Monitoring Report MY07/Closeout

**Sandy Bridge Restoration Site
DMS Contract 6400
DMS Project Number 96920**

**DWR #: 15-0414
USACE Action ID: 201500827
Rutherford County, North Carolina**

Re: Response to Sandy Bridge Farm MY07 Report Comments

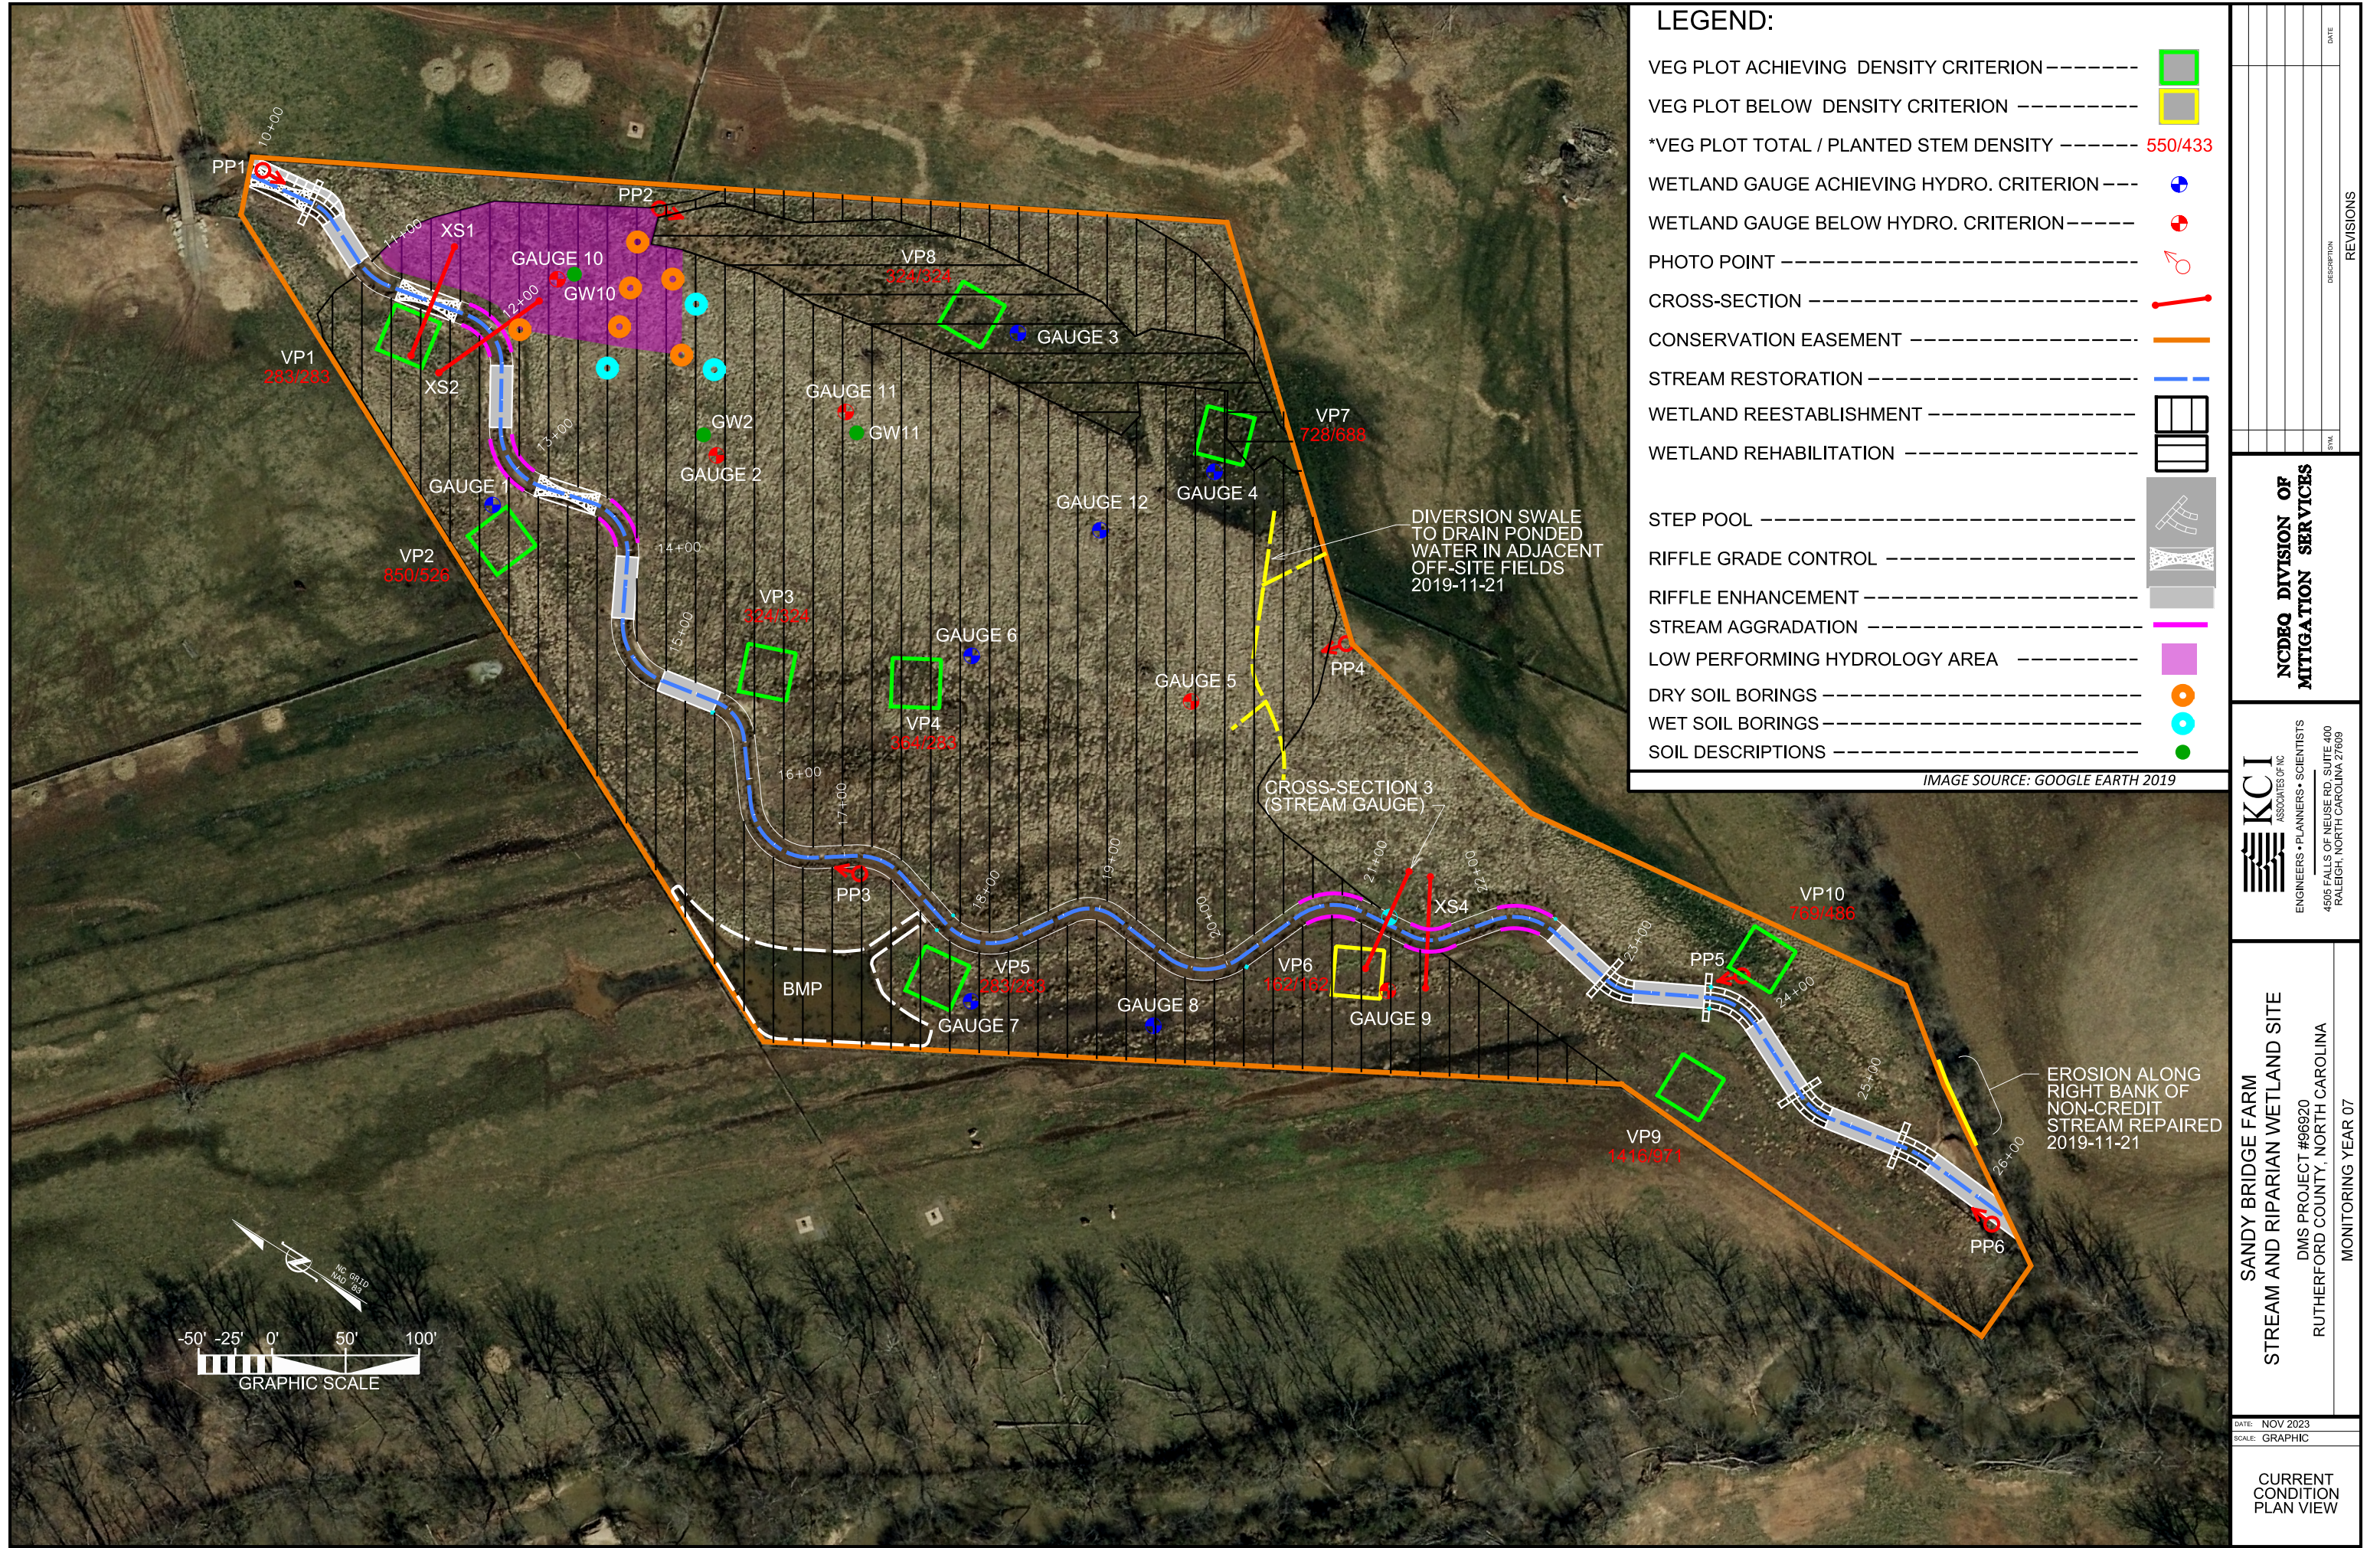
- Please provide a georeferenced CCPV as part of the report, or in the digital support files. None of the PDF CCPVs included in the report or the support files are georeferenced.

- Thank you for the 3 soil profiles conducted at/around GW2, GW10 and GW11, and symbols shown on the map; it would be helpful to show a) the soil profile photos associated with these borings, if available, and b) soil boring labels (IDs) on the CCPV.
KCI Response: Photos of the soil borings are not available but labels have been added to the CCPV.

KCI Response: Georeferenced versions of the CCPV have been added to the digital files.
